REV.  
D

SAE AS9696

BOLT, MACHINE - DOUBLE HEXAGON EXTENDED WASHER HEAD, PD SHANK, CORROSION AND HEAT RESISTANT STEEL, UNS N07001, 165 KSI MIN, .1900-32 UNJF-3A

ISSUED 1999-08 REVISED 2011-07

FIGURE 1 - BOLT

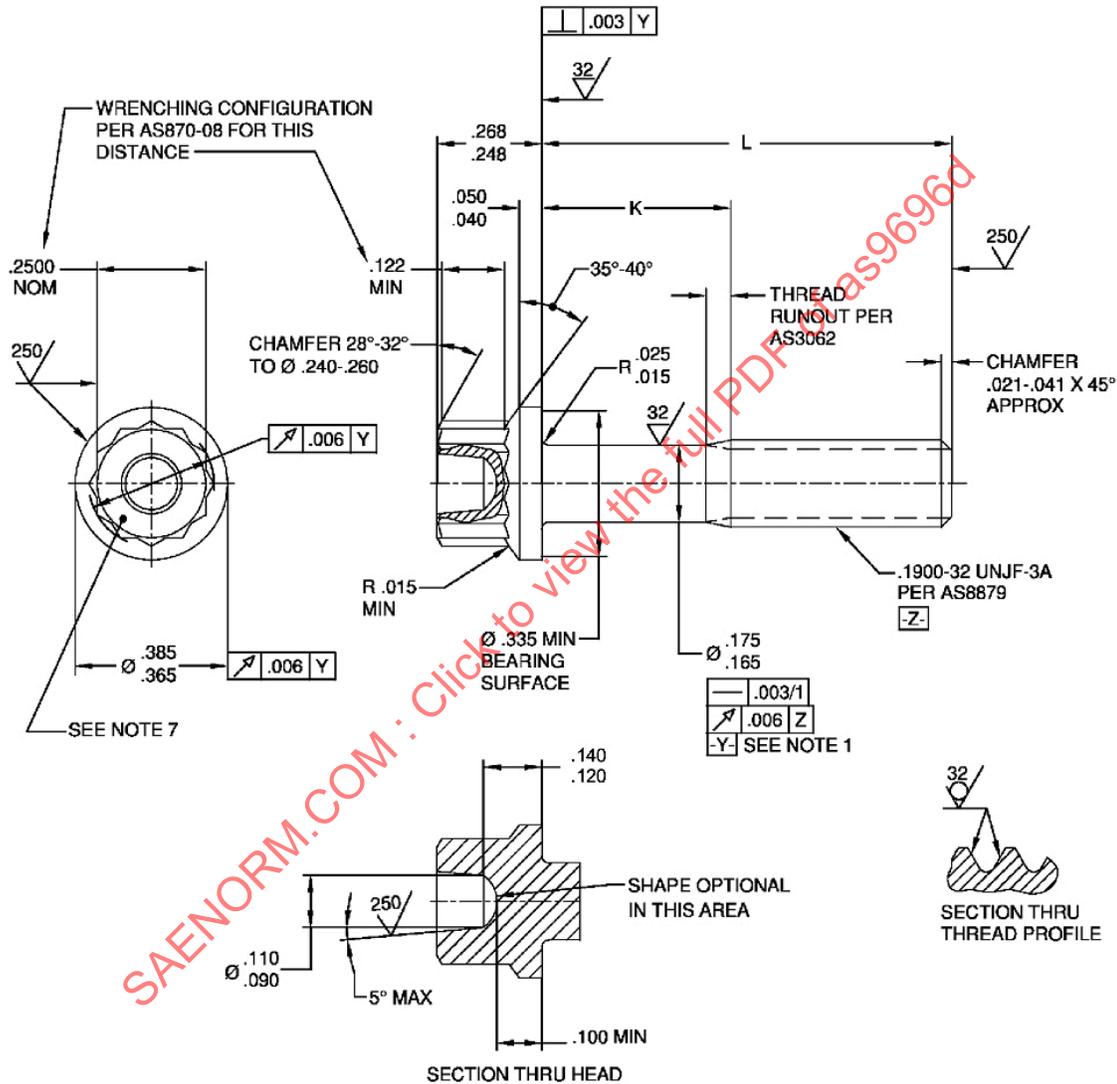
CORRECT TYPOGRAPHICAL ERRORS IN TABLE 1 AND FIGURE 1. FOR MS9696-30 REVISE L DIM FROM "2.115 - 1.135" TO "2.115 - 2.135". IN FIGURE 1, SECTION THRU HEAD, REVISE .140 DIMENSION TO .120-.140.
